INSTRUCTION TO SERVICE ITS: 3559

SECTION: 231 Cooling System	MODEL: <input type="checkbox"/> 30FT <input type="checkbox"/> 35FT <input checked="" type="checkbox"/> 40FT <input type="checkbox"/> 60FT <input checked="" type="checkbox"/> DSL <input type="checkbox"/> CNG <input type="checkbox"/> LNG <input type="checkbox"/> ELEC	TYPE: <input type="checkbox"/> HIGH FLOOR <input checked="" type="checkbox"/> LOW FLOOR	WRITTEN BY: Bik Dhaliwal
---------------------------------------	---	---	---------------------------------

Remove & replace hydraulic and power steering pump lines

Figure 1 – Mounting Bracket Installation

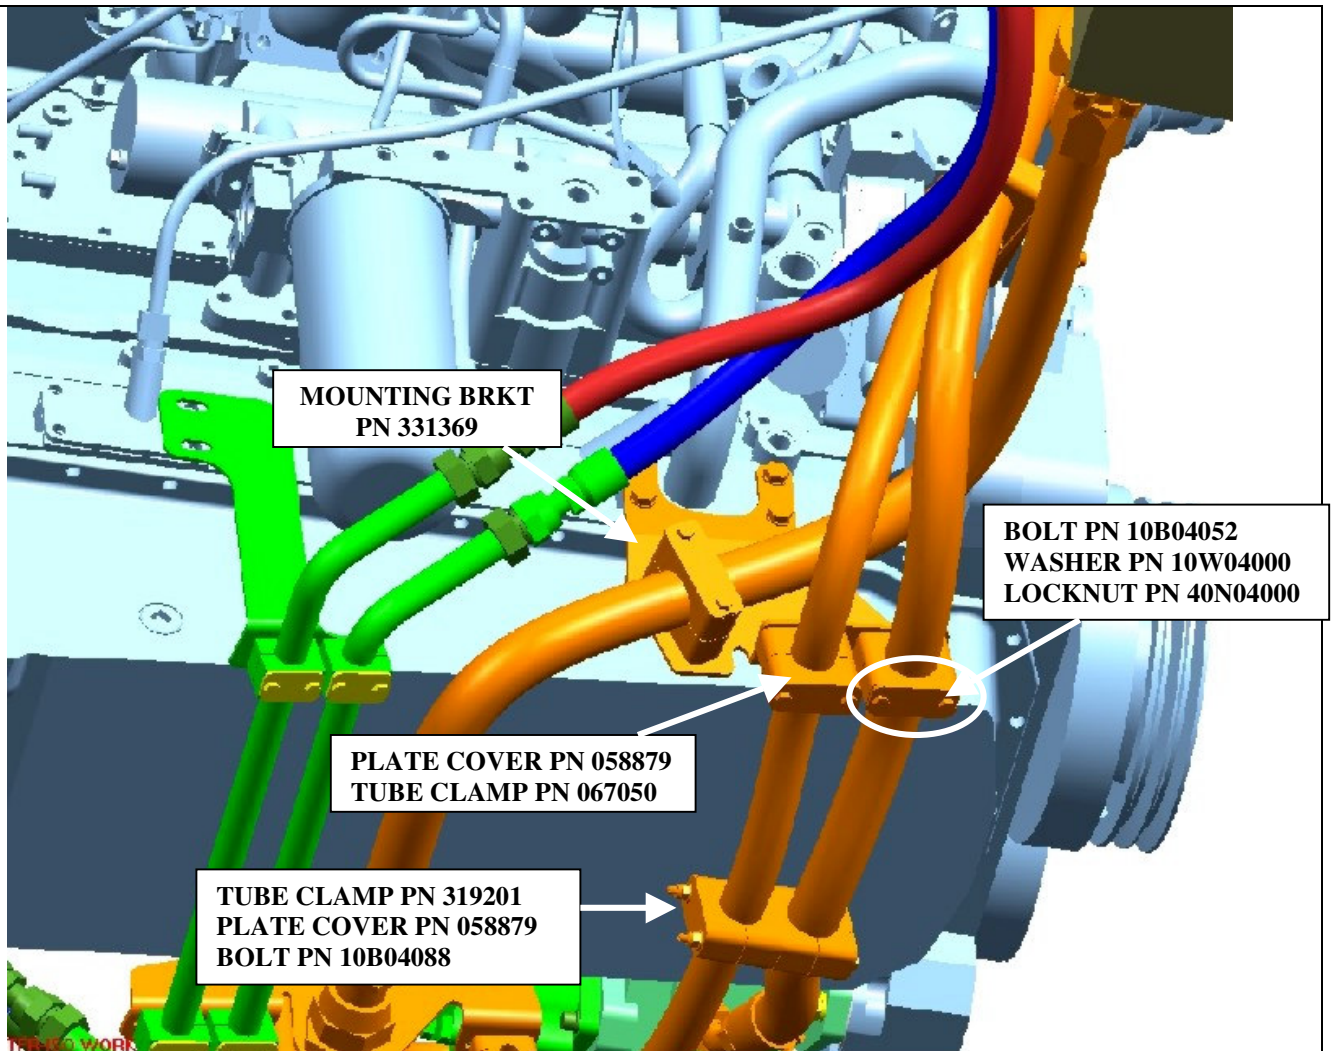
1. Turn the main battery disconnect switch to the "OFF" position.
 2. Raise coach in accordance with the New Flyer Service Manual or use a service pit.
 3. Open the rear engine access door.
- ☞ NOTE: Place a drip tray underneath at the ends of the hydraulic and P/S lines (NF PN 307432 & 307339 respectively) and hydraulic manifold to catch any fluid runoff.**
4. Undo clamps retaining the hydraulic line (NF PN 307432). Store hardware for reinstallation.
 5. Disconnect the attached hydraulic line that runs to the hydraulic manifold.
 6. Undo clamps retaining the power steering lines (NF PN 307339). Store hardware for reinstallation.
 7. Disconnect the attached power steering line that runs to the hydraulic manifold.
 8. Remove the existing hydraulic and power steering lines bracket and replace with new bracket (NF PN 331369) reusing existing hardware to secure. Refer to Figure 1.

Figure 2A – Line Installation

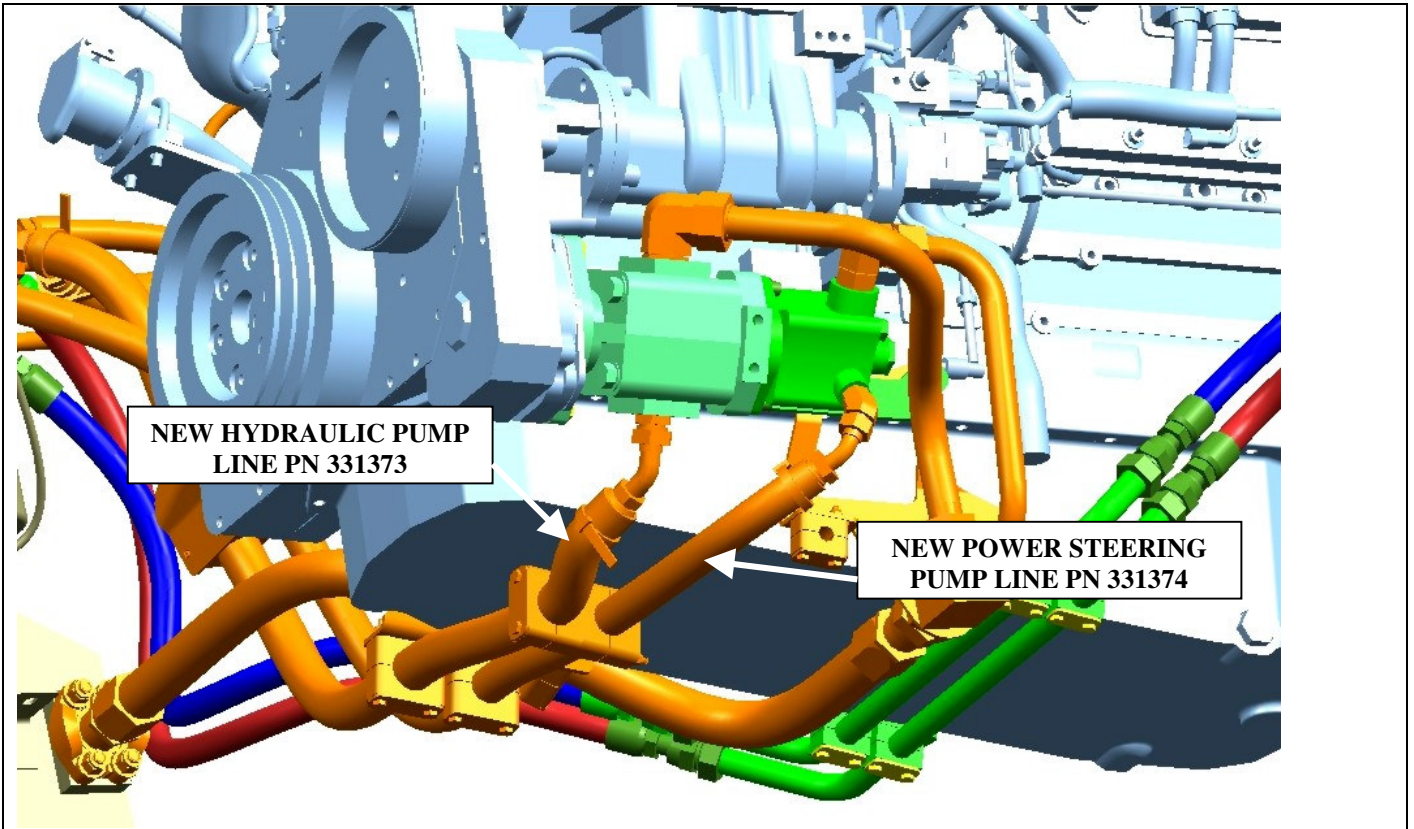
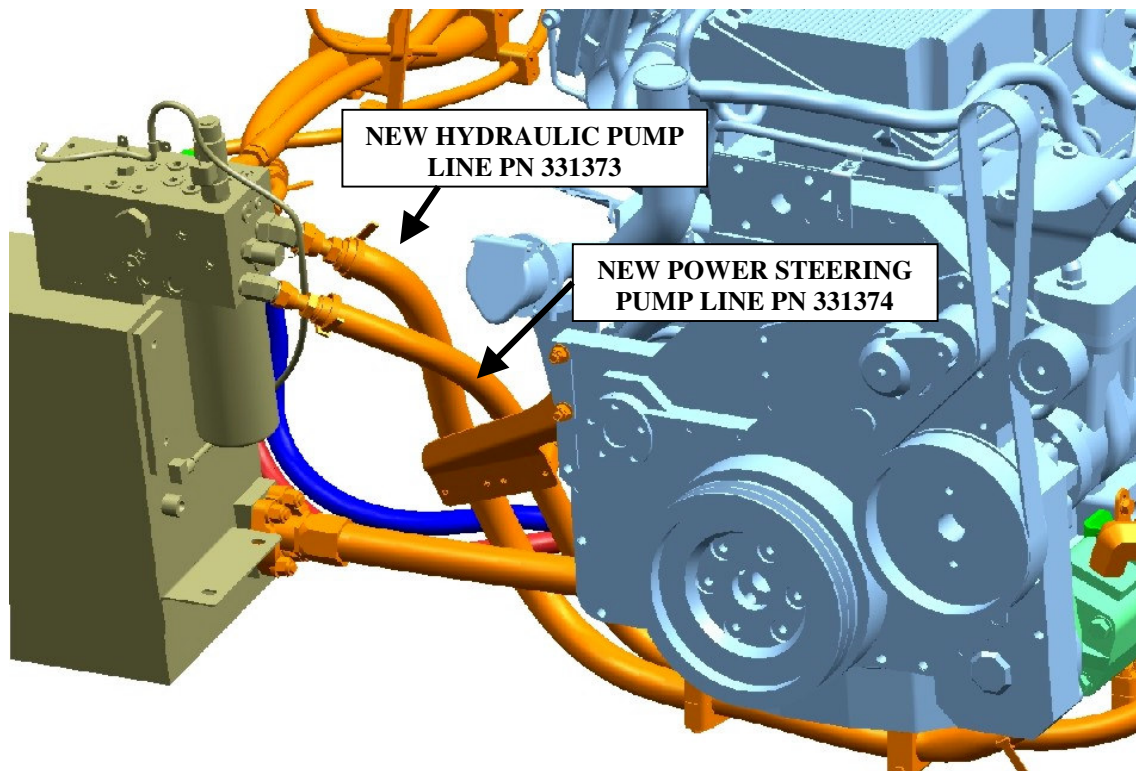
9. Position the new hydraulic line (NF PN 331373). Ensure the installed line has no kinks or potential chaffing points. Connect the fan pump side first and then proceed to route it to the hydraulic manifold. **Torque both ends to 65-70 FT-LBS.**
10. Position the new power steering line (NF PN 331374). Ensure the installed line has no kinks or potential chaffing points. Connect the power steering pump side first and then proceed to route it to the hydraulic manifold. **Torque both ends to 65-70 FT-LBS.**
11. Add tube clamps (NF PN 067050) to the bracket attached in Step 8. Refer to figure 1 for hardware.
12. Add second set of tube clamps (NF PN 319201) to the lines as shown in Figure1.
